SUNDRY NOTICES AND REPORTS ON WELLS

8. Well Name and No.
Wilderspin Federal #3

9. API Well No.
30-015-25501

**Wilderspin Federal 3
30-015-25501
Southwest Royalties Inc.
April 19, 2016
Conditions of Approval**

Proposed **Wellbore Schematic (From Surface to TD)**

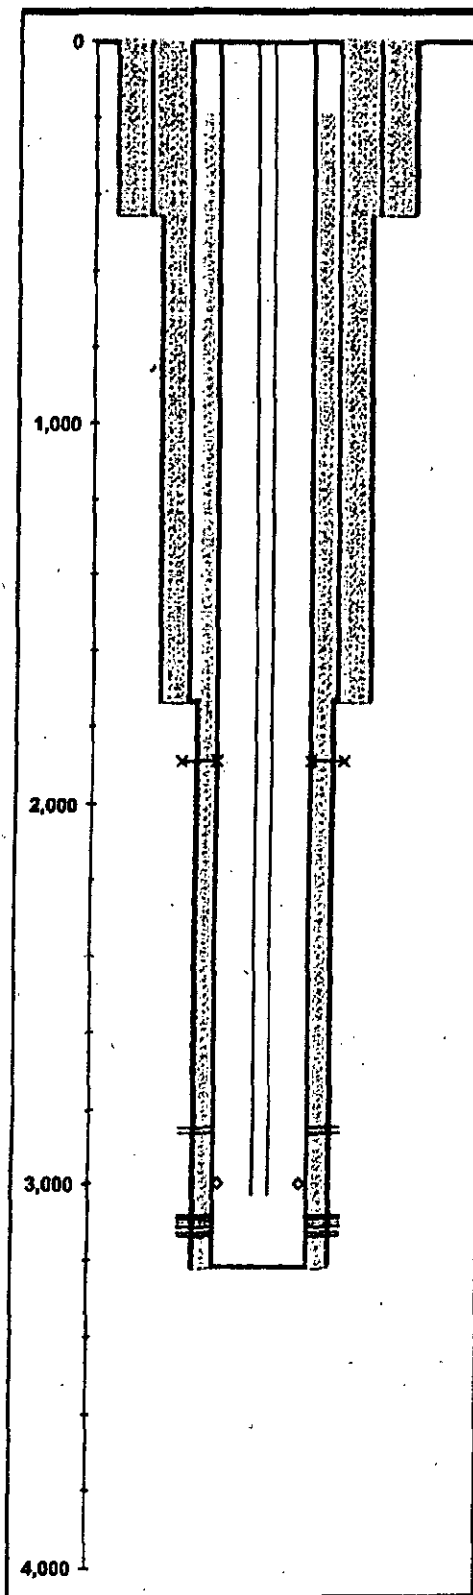
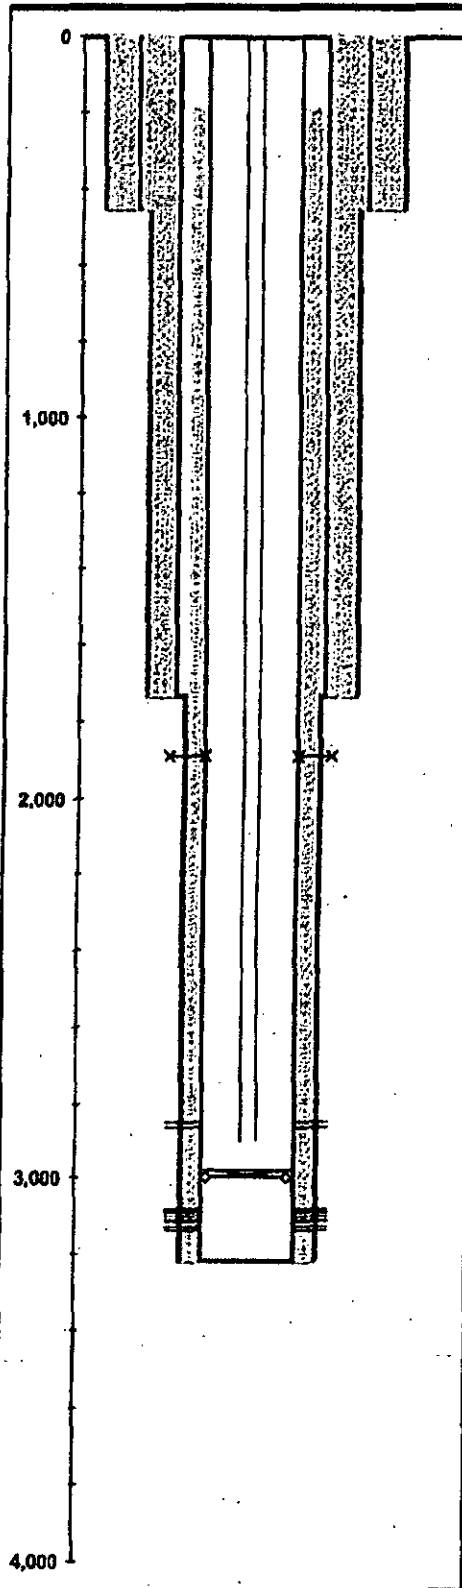
We will be setting a CIBP at 3000' and dumping 35' of cement on top of the plug. We will be setting the plug above the perfs from 3084'-3138' and will only be producing from the perfs from 2852'-2870'.

Proposed CIBP @ 3000' + 20' cement

- 1. Operator shall set a CIBP at 3,000' with a minimum of 35' class C cement on top. TAG required.**
- 2. Must conduct a casing integrity test before perforating and fracturing. Submit results to BLM. The CIT is to be performed on the production casing to max treating pressure. Notify BLM if test fails.**
